Planning Committee

5 November 2020

Agenda Item Number	Page	Title
12	(Pages 1 - 9)	Additional supplementary information for application 20/01830/F – Proposed Roundabout access to Graven Hill and Wretchwick Green, London Road, Bicester.

Technical Note		 <p>CITY INFINITY</p> <p>Designing for active urban travel</p>
Project	A41 / Pioneer Roundabout	
For	Paul Troop	
Organisation	Bicesters Bike Users' Group	
Date	4/11/2020	
www.cityinfinity.co.uk / contact@cityinfinity.co.uk

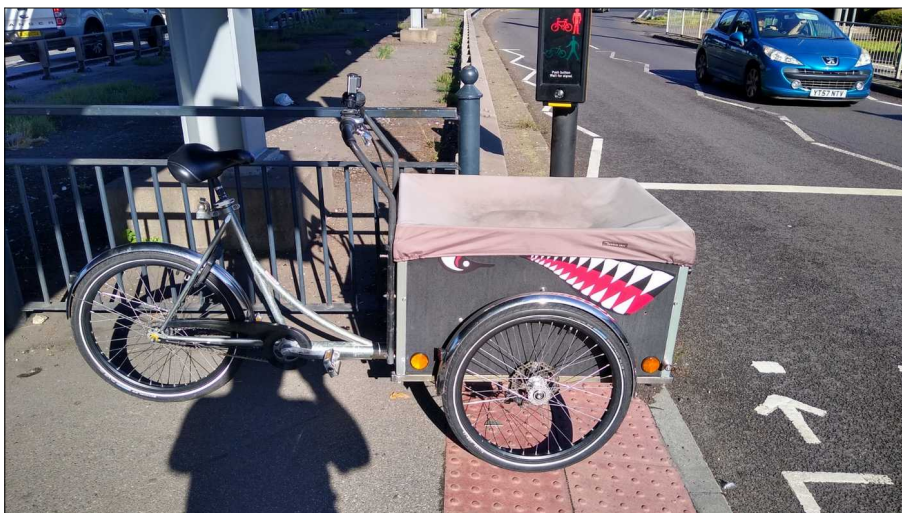
The Pioneer Road and north-west arms of the roundabout each have two-stage toucan crossings arranged in line across each road, set back around 20m from the outside edge of the roundabout. The south-east arm has a single stage toucan crossing some 70m from the outside edge of the roundabout. The stub on the north-east side of the roundabout has uncontrolled crossing points within 5m of the outside edge of the roundabout.

- The geometry of the roundabout is likely to enable excessive entry, circulatory and exit speeds by drivers which may impact on the safety of people walking and cycling in terms of approach speed at the crossing points and loss of control incidents.

- We understand that the speed limit through the roundabout is to be 50mph on the A41 arms with the other two arms being 30mph. Department for Transport Circular 01/2013, *Setting Local Speed Limits*, suggests that the speed limit of the majority of the arms should persist or the lower where there an equal division (Paragraph 41) – this suggests that 30mph should be the selected speed here.

- The width of the refuge island on the Pioneer Road arm is less than 5m which constrains waiting space and buffering from general traffic.
- The width of the refuge island on the north-western arm of the A41 is 5.1m which may leave people feeling exposed to general traffic.

- The verge buffer to the cycle track on the north-west arm of the A41 appears to be around 1m in width. In Local Transport Note 1/20 *Cycle Infrastructure Design*, the desirable minimum width for a 50mph situation is 2m (Table 6.1).

- The position the toucan crossing on the south-east arm of the A41 is significantly beyond the desire line for people wishing to cross from east side of Pioneer Road to the future development site to the north-east. Regardless of the toucan crossing, people will cross on the desire line at a risky location.

- The uncontrolled crossing point on the stub arm will be intimidating and difficult to cross if this remains the arrangement in either the permanent state or during an interim construction stage. The exit speeds from the roundabout are likely to be high and crossing the entry lanes are likely to be difficult where one lane moves at a different speed or rate to the other.

- The use of toucan crossings necessitates push-buttons to register crossing demand. The standard set back of the push buttons from the carriageway (depending on design speed) means that some cycle users will struggle to reach the push buttons, especially those using non-standard or adapted cycles (Photograph 1).

- Two-stage toucan crossings require users to use push-buttons twice and they can potentially have excessive waits in the centre of busy/ fast moving general traffic which can be intimidating in use.

- Geometry of the roundabout - this is covered in my note of yesterday. The geometry of the proposals is that of a normal roundabout, as set out in CD116.

- Speed limit through the roundabout - this is covered in my note of yesterday.
- Width of refuge islands - the proposed width is considered adequate and this is not picked up in the safety audit as a problem.

- The verge buffer is in places subject to physical constraints, and I acknowledge that it is below the desirable minimum of 2m for 50mph. As stated in my note of yesterday, OCC will be consulting on a 40mph limit for this stretch of the A41, and once the side roads are connected, will consider a change to 30mph at the roundabout itself, as this would be in line with DfT Guidance.

- The proposed toucan crossing on the south-east arm is acknowledged to be well off the desire line. For cyclists this will add only a few seconds delay. Its position is dictated by the width of the road and constraints of the highway boundary beyond Graven Hill's frontage.

- The informal crossing over the stub of the roundabout is considered acceptable because there will be no traffic movements for pedestrians and cyclists to cross while it is still a stub. A future crossing would be provided by Wretchwick Green, as it would need to be located beyond the existing highway boundary. Provision of a continuous kerbed ped/cycle route here would be abortive work.

- The set back of push buttons is a matter that can be considered as part of the detailed design.
- Two stage toucan crossings can be set up so that when the first button is pressed it automatically triggers the second stage to be called after a suitable interval, thereby minimising the delay to pedestrians and cyclists. The new crossings would be designed this way.

- Lane widths - the roundabout will carry high volumes of HGV traffic and therefore lane widths need to be wide enough to ensure vehicles do not encroach on other lanes, risking side swipe accidents. The lane widths are no wider than they need to be, but this can be checked at detailed design stage.

- Speed limit strategy for the A41 - this is covered in my note of yesterday.
- Wider island on north-west arm of the A41 - this has been considered and taking into account the required width of verges and paths, it isn't possible to widen it.

- The southeastern A41 approach is proposed as three lanes - this is needed to provide sufficient capacity, in particular for the future South Eastern Perimeter Route, which will take traffic out of Bicester.

Figure 1 – A third, set back, toucan push button (circled blue)

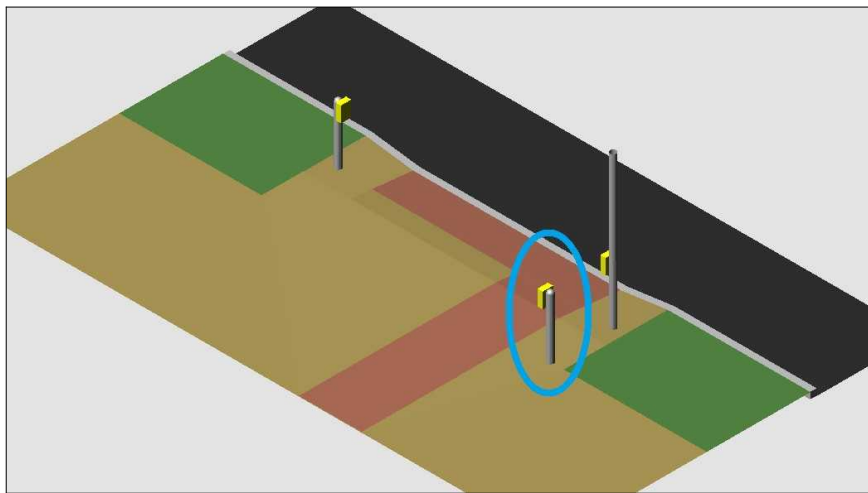
- The position of the toucan crossing push buttons should be reviewed against the requirements of users of non-standard and adapted cycles. Section 5.4 of LTN1/20 sets out more advice on cycle sizes, including a “design cycle”. With decent verge buffer depths, it might be desirable to provide a third push button position set back

from the usual push button positions to the left and right of the toucan crossings (Figure 1) to aid such users.
